LAND USE APPLICATION SUMMARY

Property Location: 101 1st Avenue N
Project Name: 101 1st Avenue N Townhomes
Prepared By: Kimberly Holien, Senior Planner, (612) 673-2402
Applicant: Shorenstein Realty Services
Project Contact: Carl Runck, Ryan Companies
Request: To construct a residential structure with 13 attached townhome units.
Required Applications:

Variance	To the minimum Floor Area Ratio requirement in the B4N, Downtown Neighborhood District.
Site Plan Review	For the construction of a new residential structure with 13 attached townhome units.

C3.2

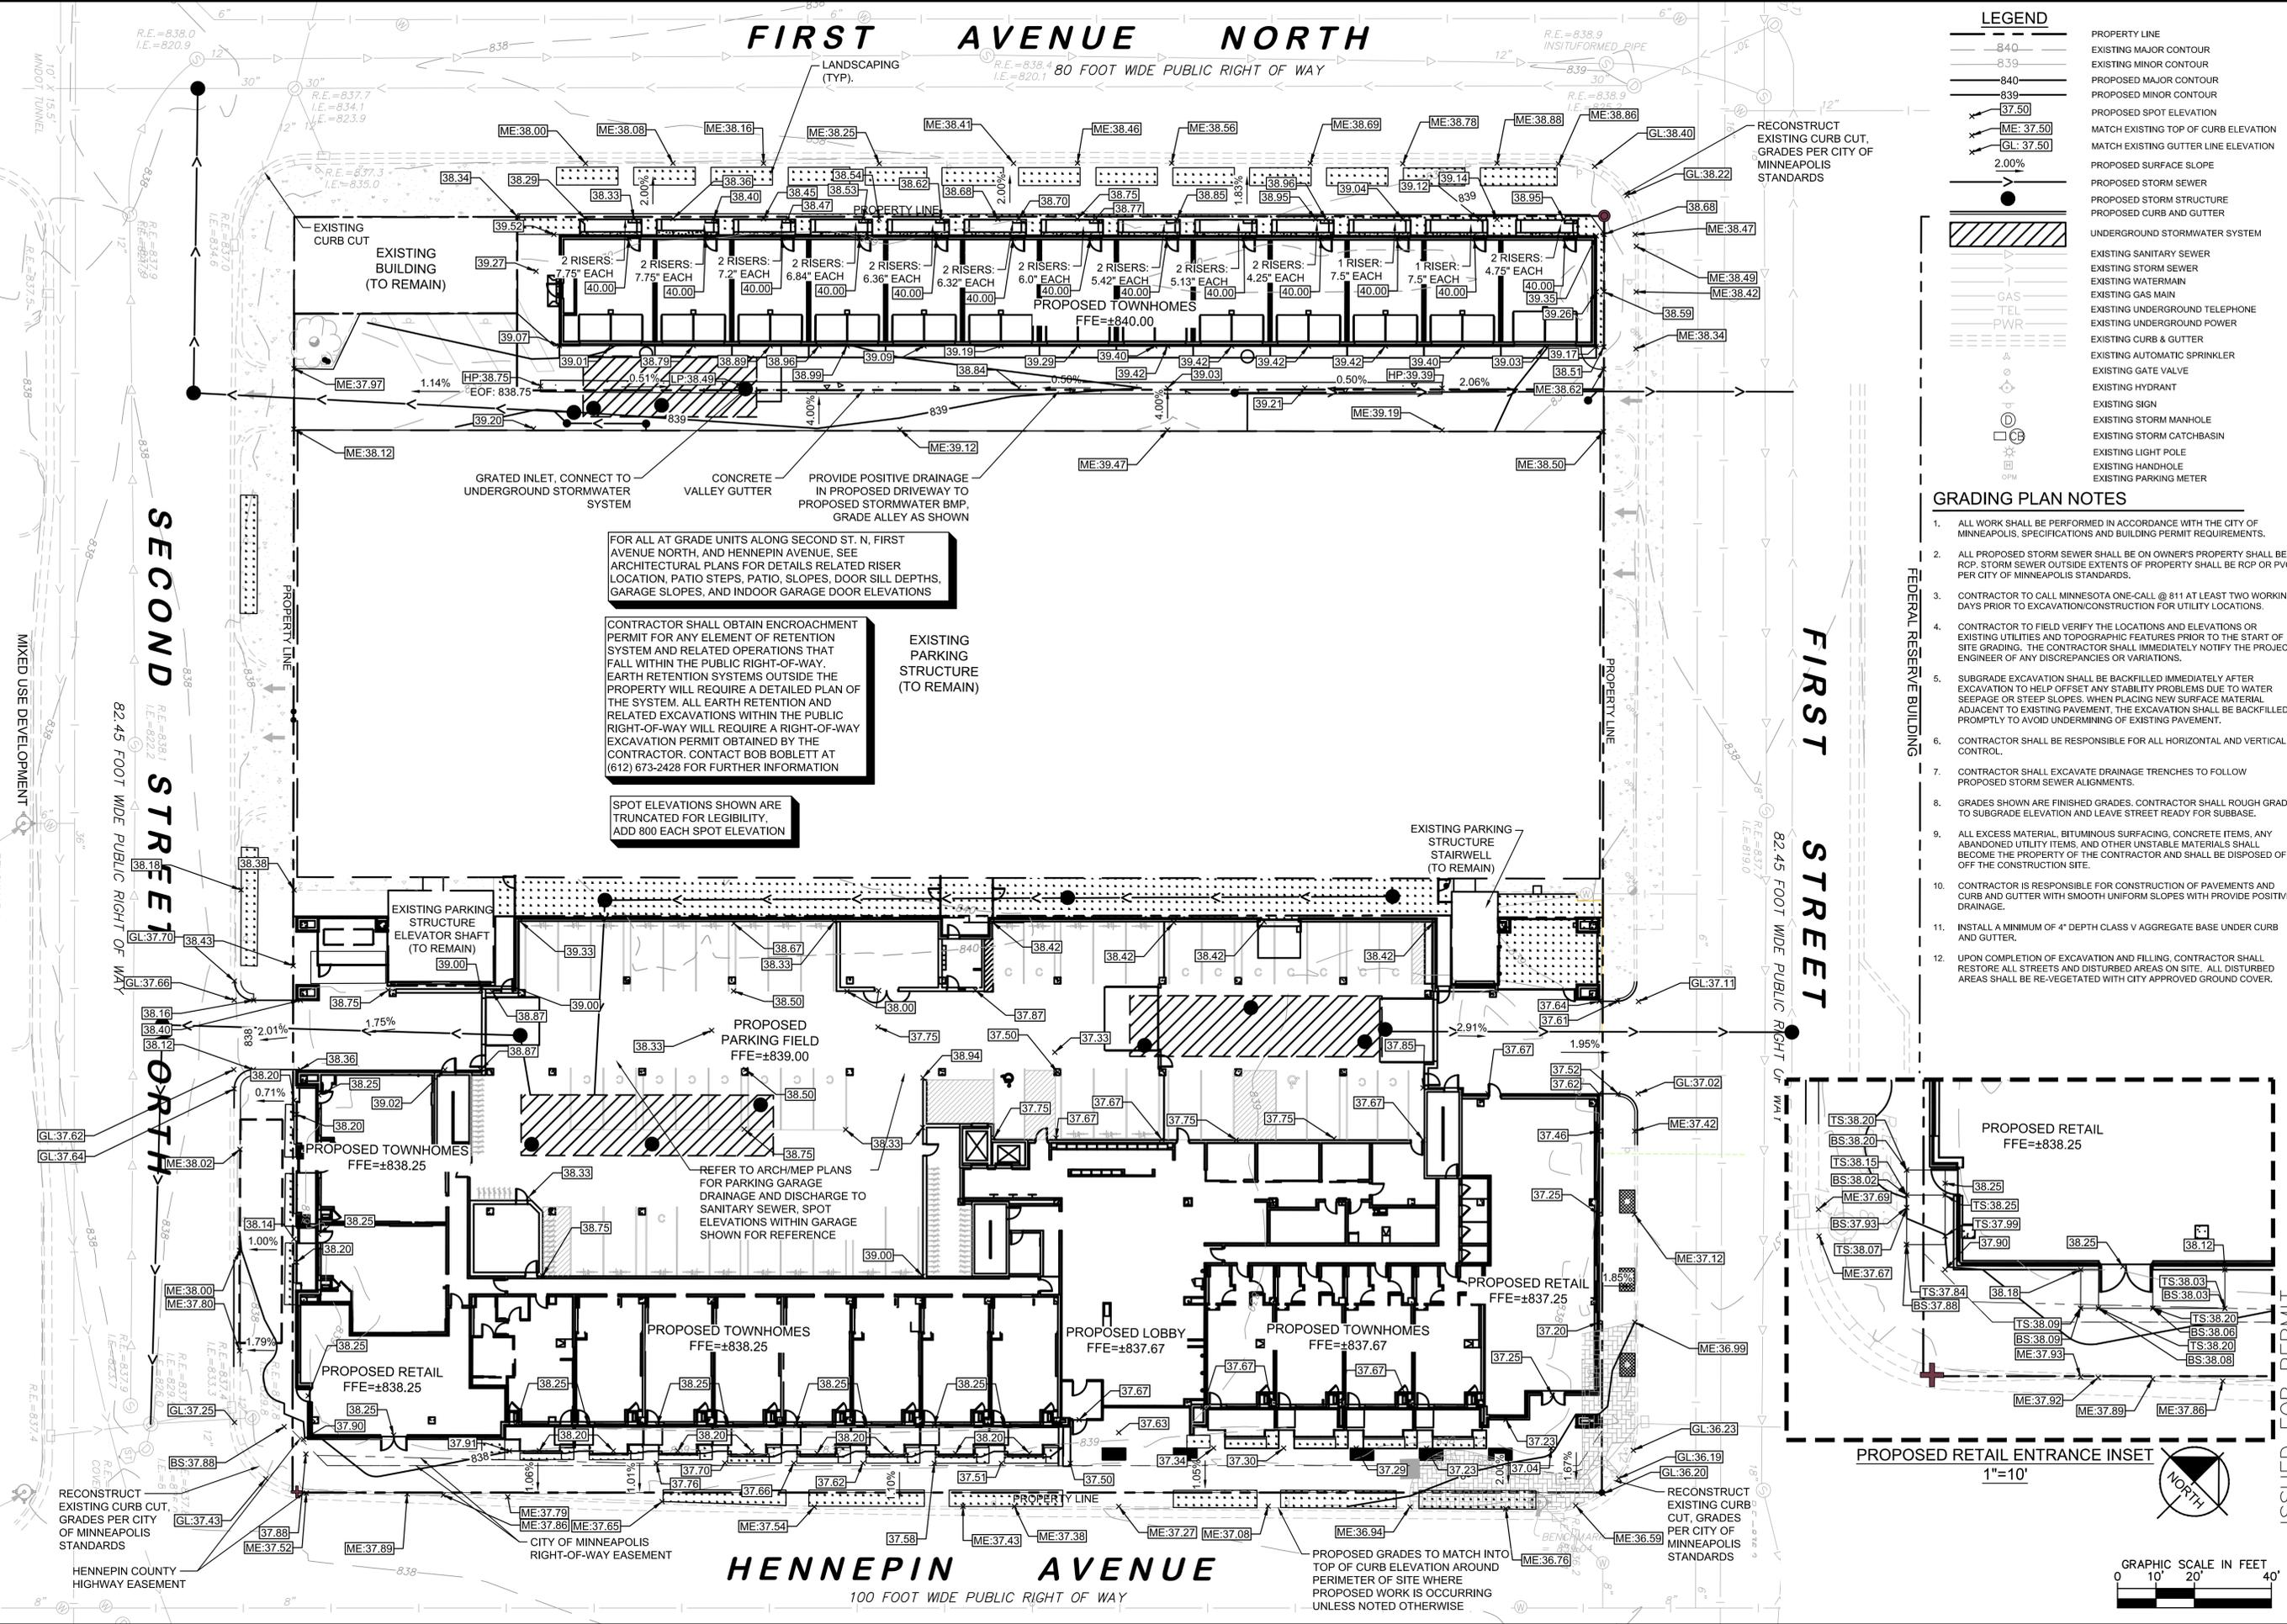
- Stormwater Management: Please provide the details for the roof paver system. Sheet C3.2 includes a note referencing the architectural plans, however the architectural plans provided contain no information.

2 TOWNHOMES - SOUTH ELEVATION
AS.11 3/32" = 1'-0"

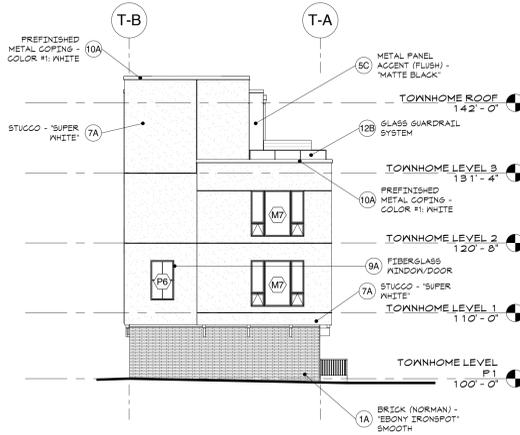
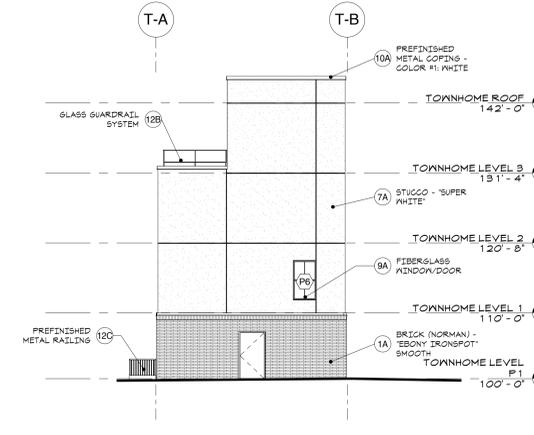
- **Blank Walls.** There two instances of blank wall in excess of 25 feet. On the north elevation, facing 1st Street N, the first floor is approximately 29 feet in length and entirely blank. On the south elevation, the third floor is approximately 29 feet in length and also entirely blank. As noted above, staff is recommending that the first floor of the north elevation be revised to meet the minimum window requirement. This would eliminate the blank wall. Therefore, staff does not recommend granting alternative compliance. Nor does staff recommend granting alternative compliance for the south elevation. The south elevation is highly visible given the 10.5 foot setback provided between the proposed building and the building to the south. As a condition of approval, a window, material change or other architectural element will be required on the third floor of the south elevation.

2. All site improvements shall be completed by October 19, 2017, unless extended by the Zoning Administrator, or permits may be revoked for noncompliance.
3. The south building wall shall maintain a minimum interior side yard setback of 11 feet.
4. Glazing equivalent to 20 percent of the first floor elevations on the north and west sides of the building and 10 percent of the fourth floor of the north shall be provided, in compliance with Section 530.120 of the zoning code.
5. The third floor of the south elevation shall be revised to include a window, material change or other architectural element to reduce the width of the blank well below 25 feet, in compliance with Section 530.120 of the zoning code.
